Approved Section 4.55 (2) Modification Application

No: SSD 6966 MOD 1 Granted on 19 August 2021

ONE SYDNEY HARBOUR

BARANGAROO

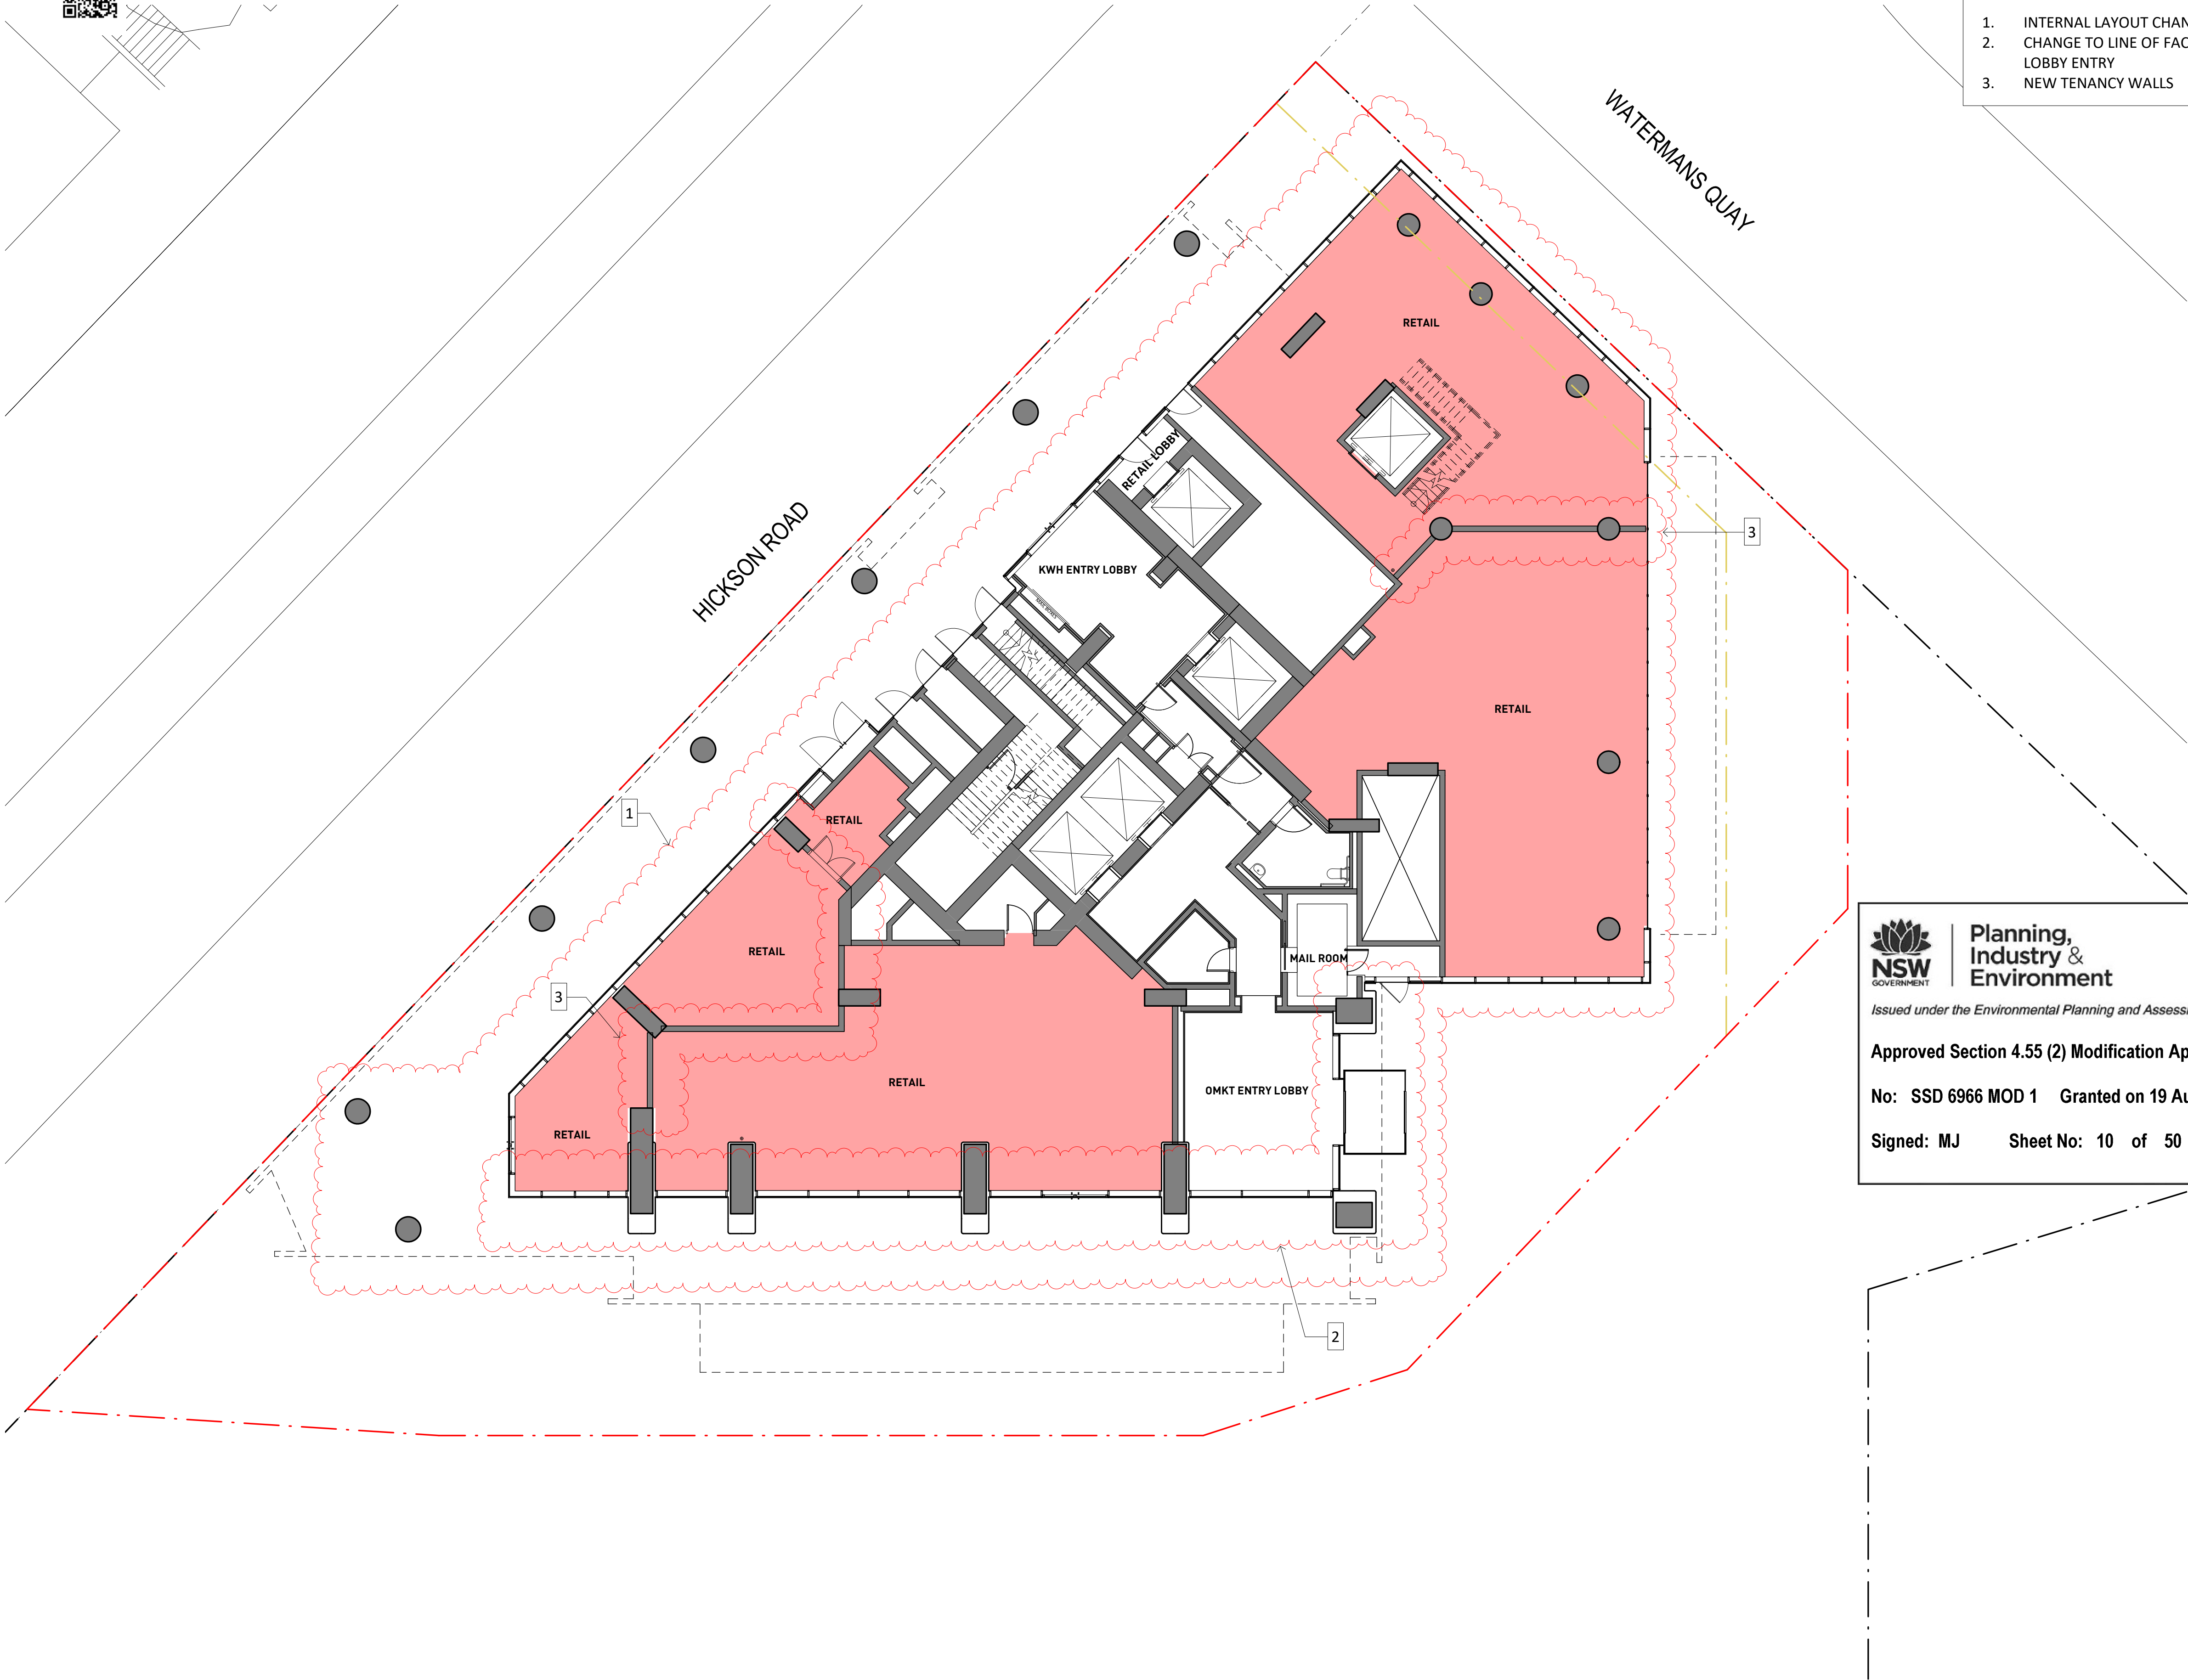
MODIFICATIONS:

1. INTERNAL LAYOUT CHANGES
2. CHANGE TO LINE OF FACADE AND LOBBY ENTRY
3. NEW TENANCY WALLS

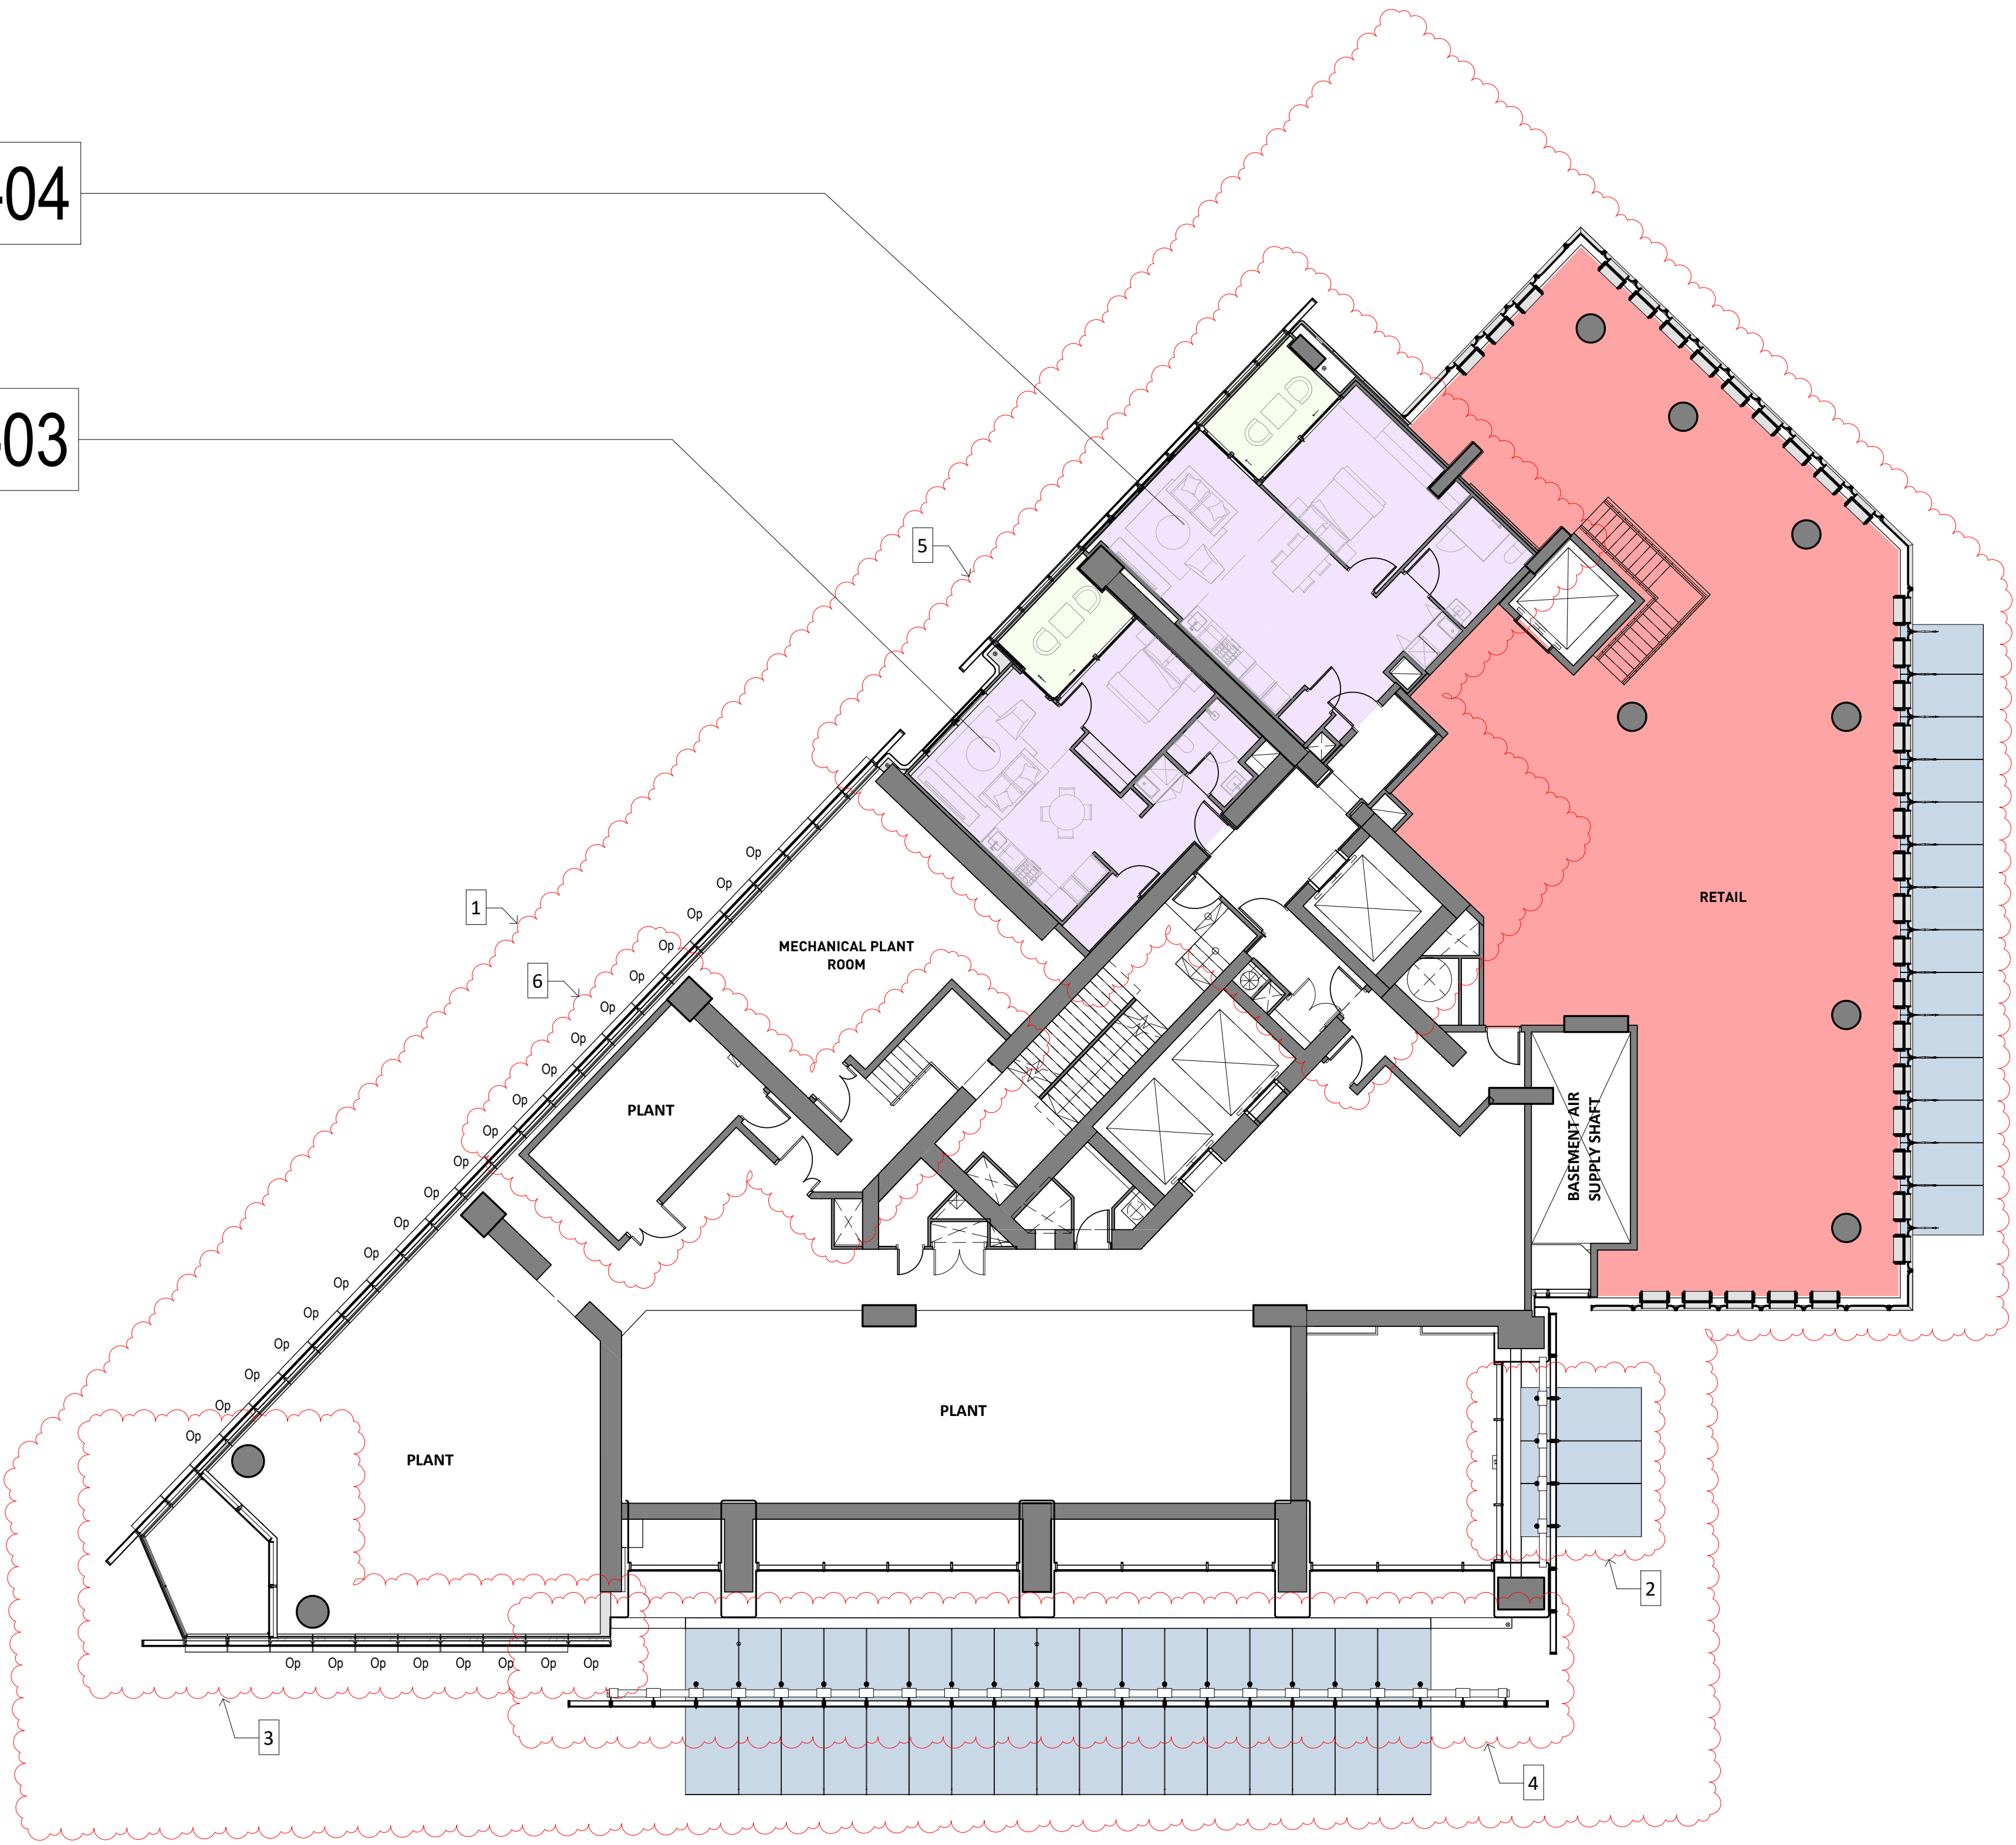
MODIFICATIONS:

1. INTERNAL LAYOUT CHANGES
2. CHANGE TO LINE OF FACADE AND LOBBY ENTRY
3. FACADE STEP OUT BY 2190mm
4. FACADE STEP OUT BY 1845mm
5. NEW KWH APARTMENTS
6. NEW PLANT LAYOUT

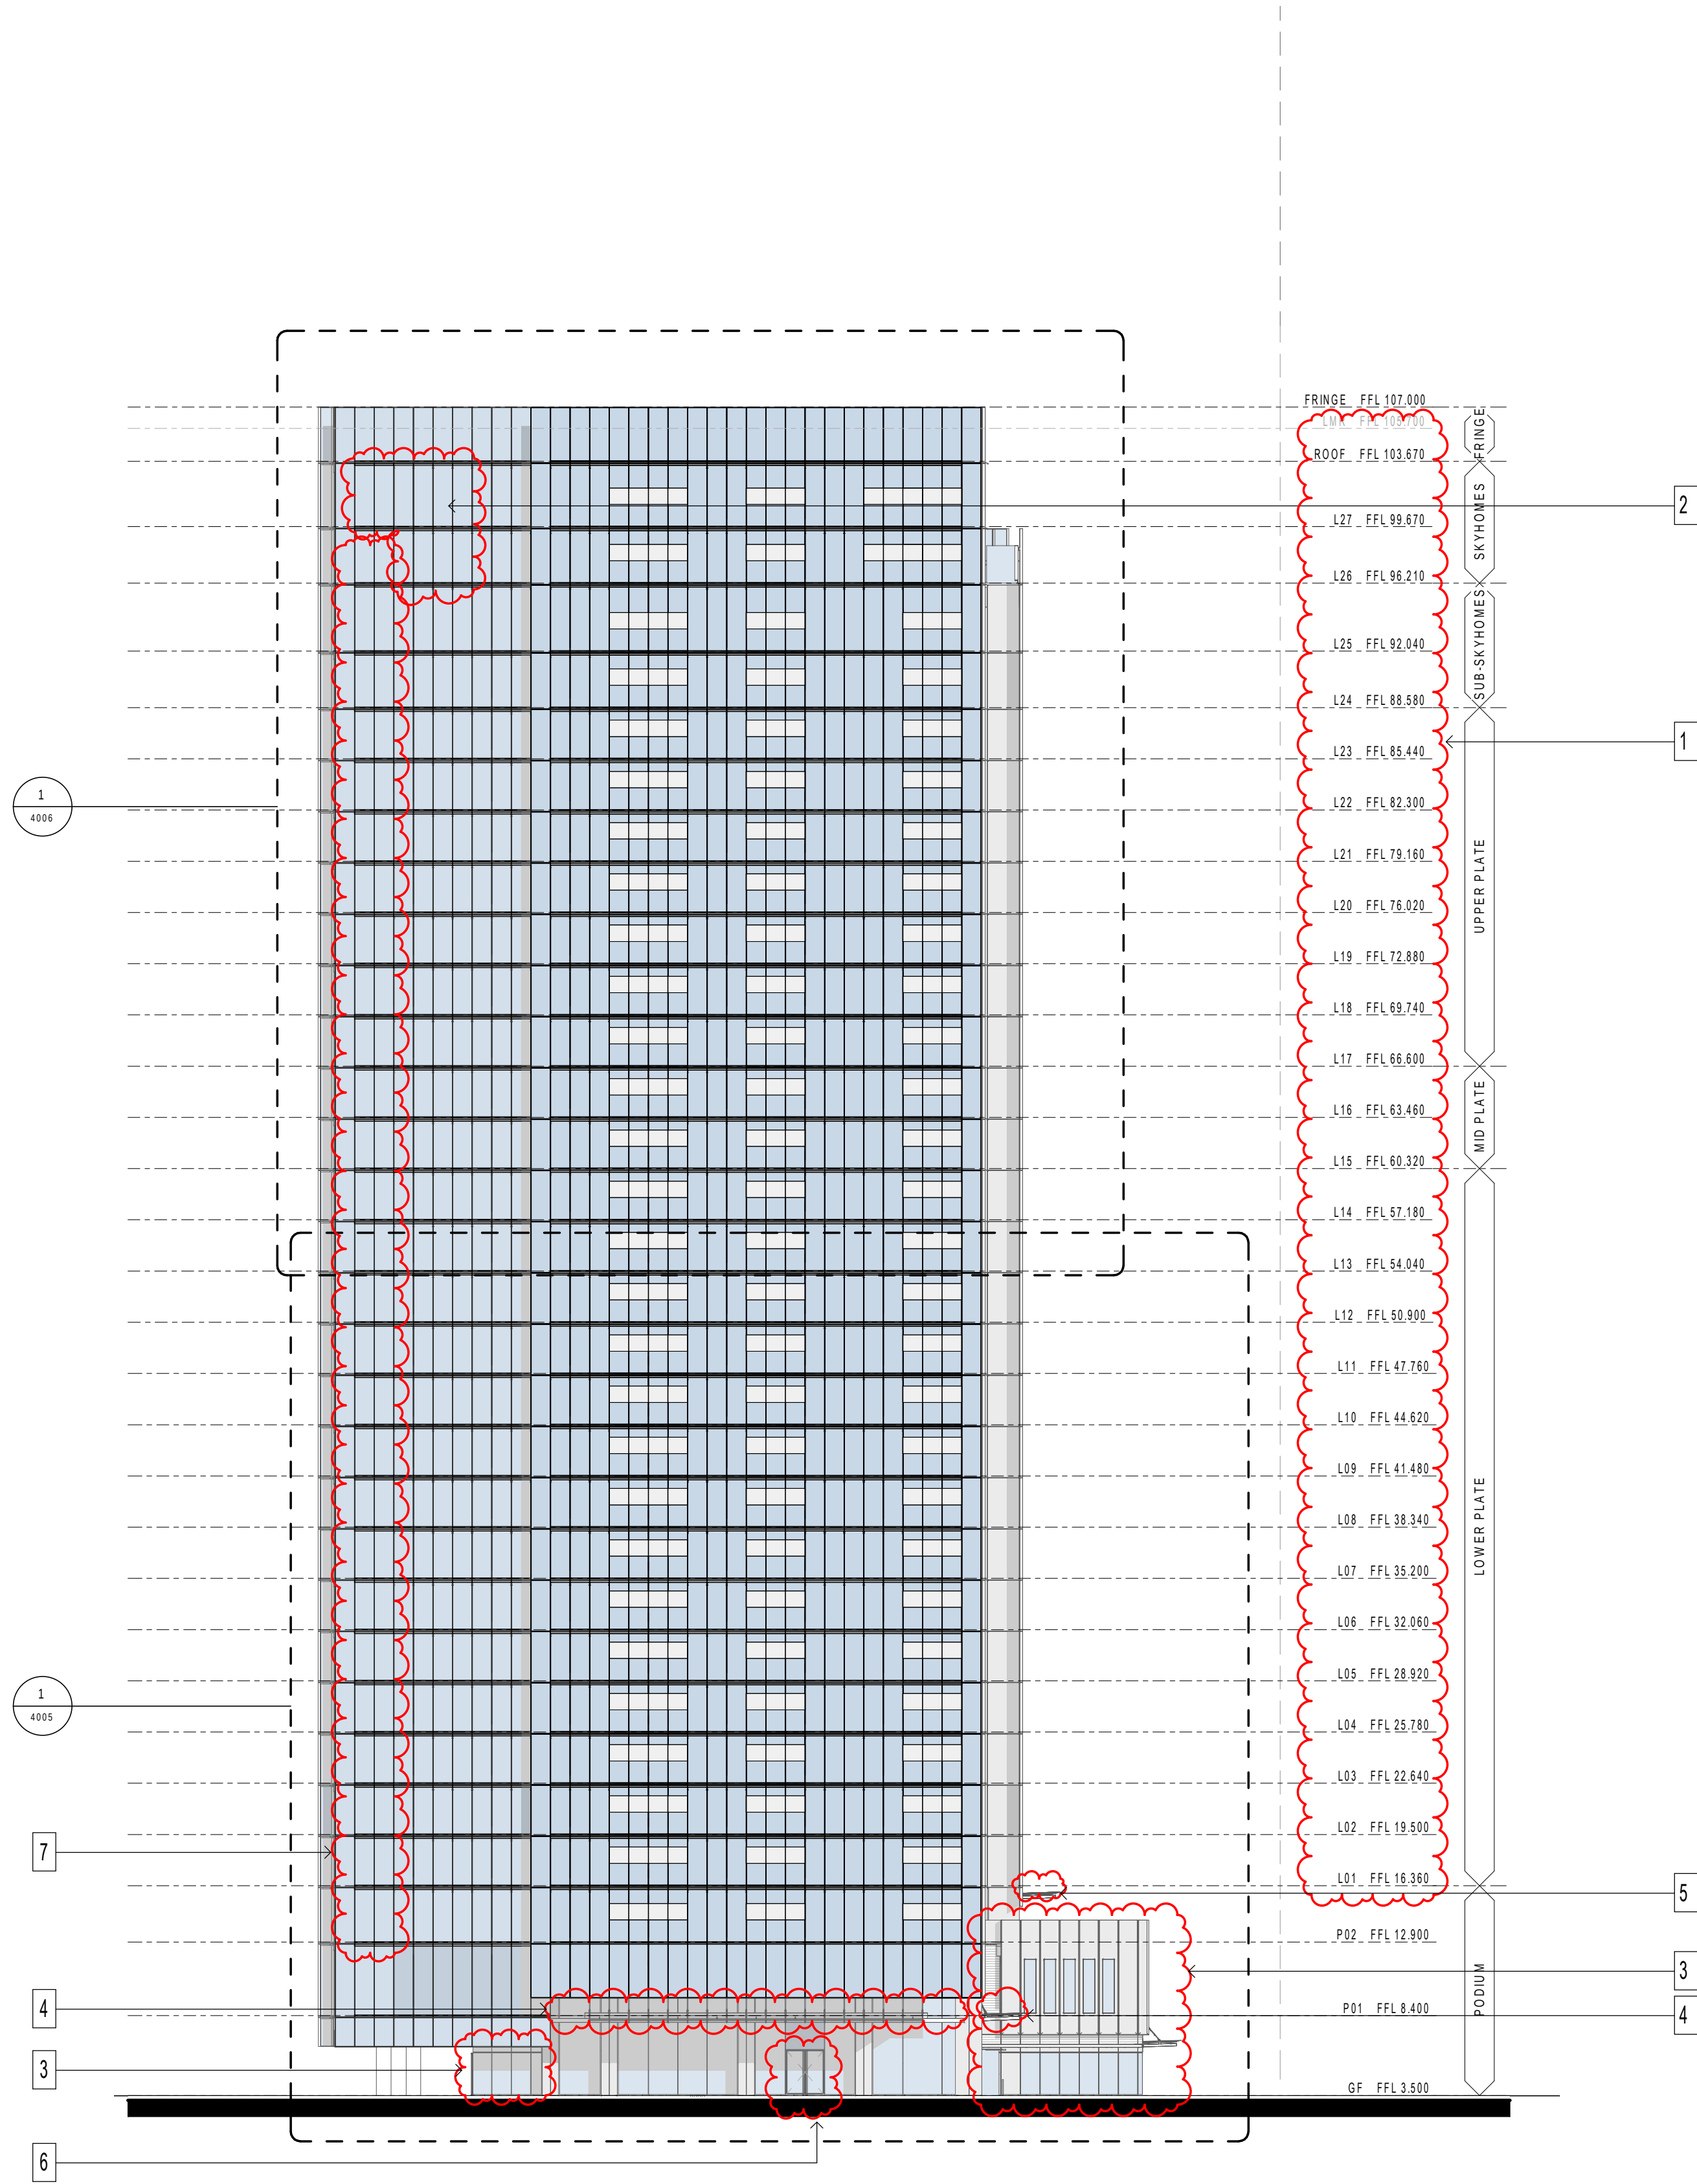
- MODIFICATION:
1. UPDATED LEVEL'S FFL
 2. REMOVED EXTERNAL SHADING DEVICES
 3. UPDATED PODIUM FACADE
 4. UPDATED AWNING DETAILS
 5. ADDED AWNING
 6. SHOWN INDICATIVE RETAIL DOOR LOCATION
 7. UPDATED BALCONIES TO FULL HEIGHT GLAZING FACADES
